ACCESSION NBR: 8002060337 DOC. DATE: 80/02/01 NOTARIZED: NO DOCKET #  
 FACIL: 50-261 H. B. Robinson Plant, Unit 2, Carolina Power and Light 05000261  
 AUTH. NAME: UTLEY, E.E. AUTHOR AFFILIATION: Carolina Power & Light Co.  
 RECIP. NAME: SCHWENCER, A. RECIPIENT AFFILIATION: Operating Reactors Branch 1

SUBJECT: Forwards suppl to 790306 request for amend to License DPR-257  
 in response to NRC 791003 request for addl info re safety  
 injection block switch. Westinghouse performed analysis  
 stating generic nature of issue & applicability.

H. B. ROBINSON STEAM ELECTRIC PLANT, UNIT NO. 2  
DOCKET NO. 50-261  
LICENSE NO. DPR-23

SUPPLEMENT TO REQUEST FOR LICENSE AMENDMENT - SAFETY INJECTION BLOCK SWITCH

Low Pressurizer Pressure / Steam Line  $\Delta p$  - Block Switch

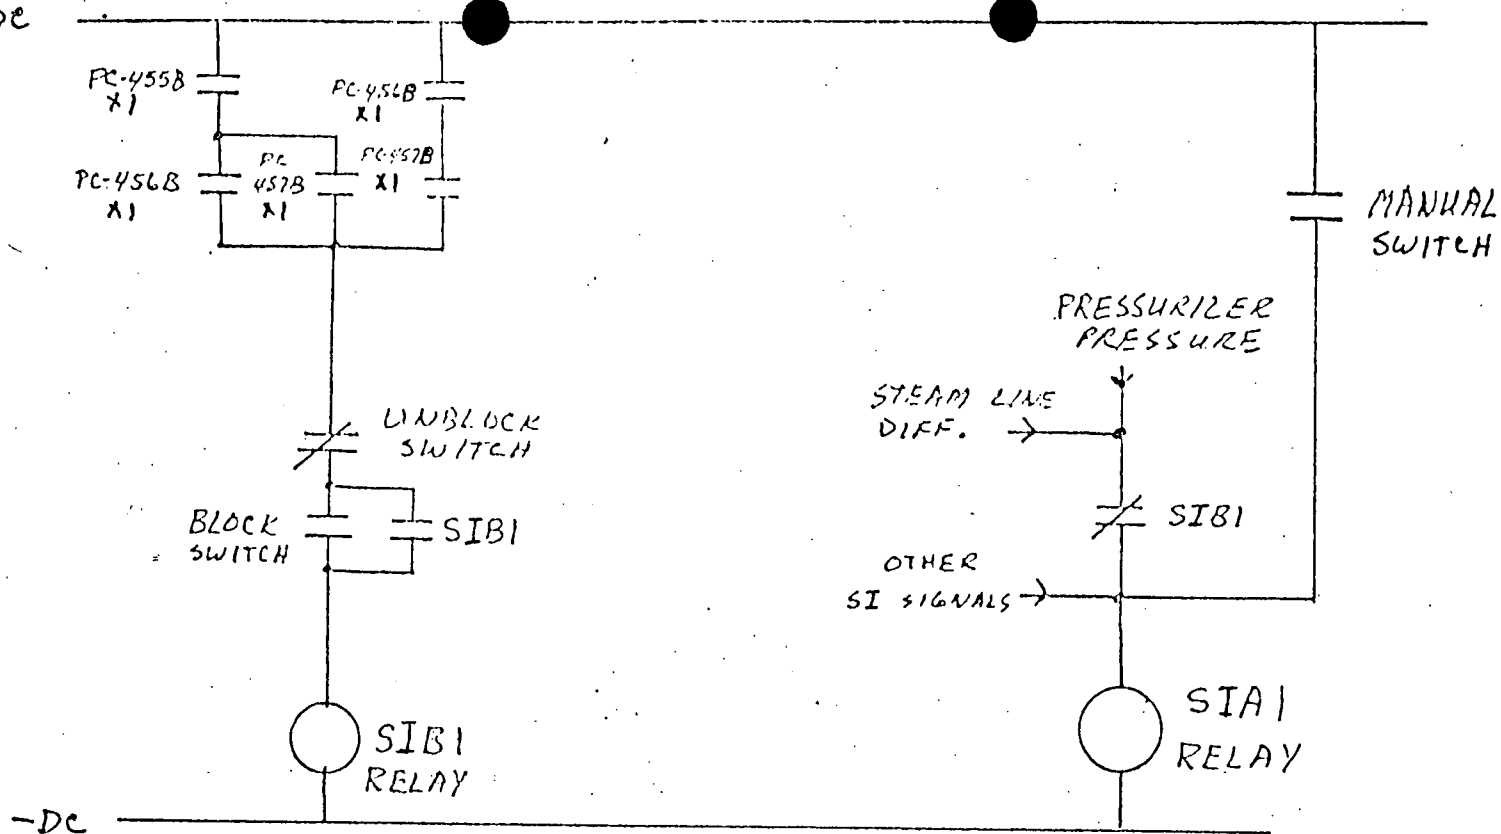
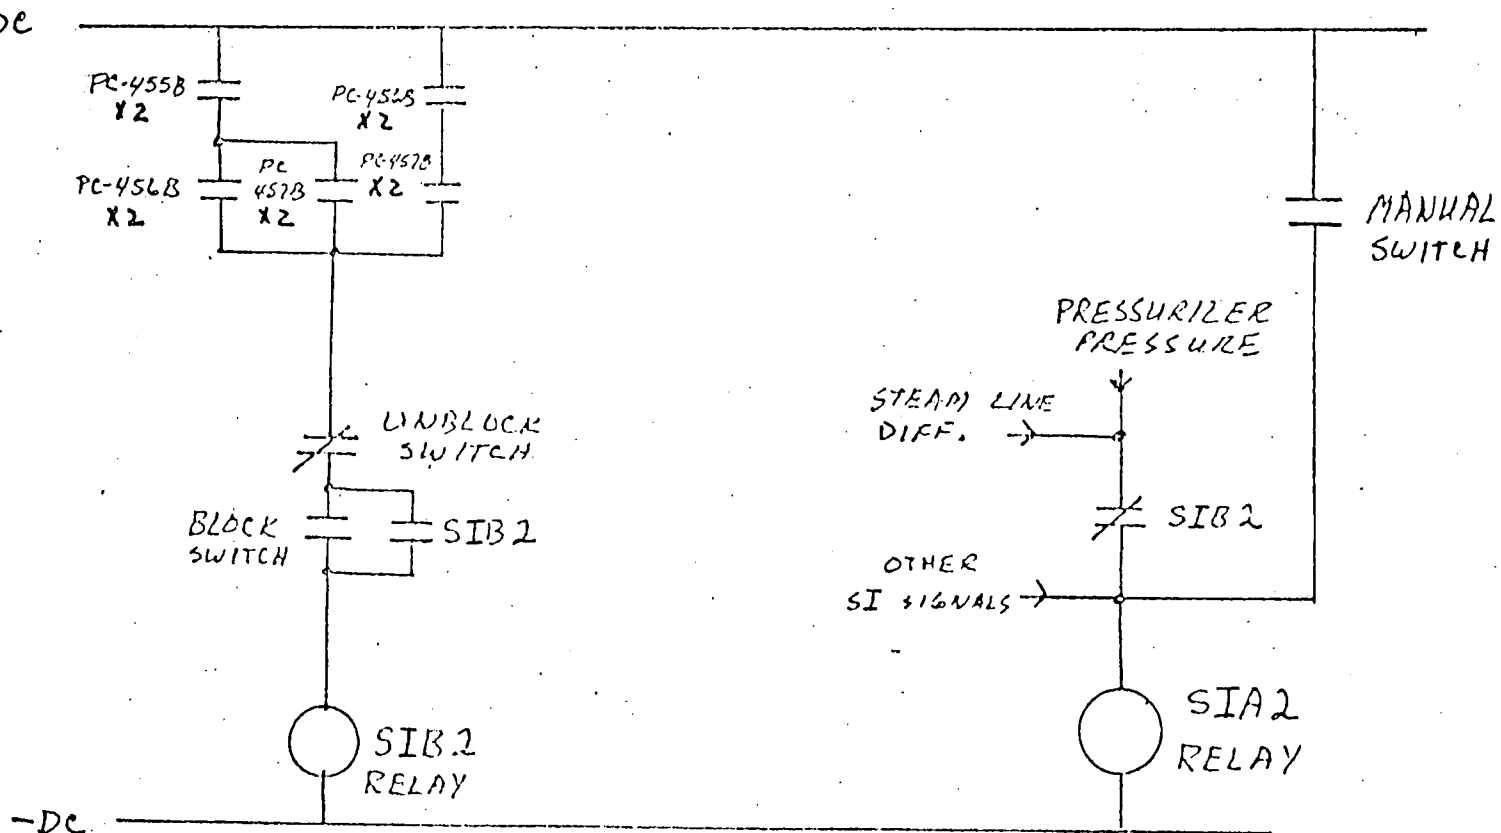
Concern No. 3 If there is only one switch, does it influence any other signals used for safeguards initiation?

CP&L Response A circuit diagram and description of the operation of the block is attached (Attachment A). As indicated above, the one switch does initiate two separate block features. However, both blocks are utilized at the same time for the same reason and under no circumstances would either be used independently. Therefore, the fact that two blocks are actuated from one switch is of no consequence.

OPERATION OF MANUAL BLOCK FOR LOW PRESSURIZER PRESSURE AND  
HIGH STEAM LINE DIFFERENTIAL OF SAFETY INJECTION INITIATION
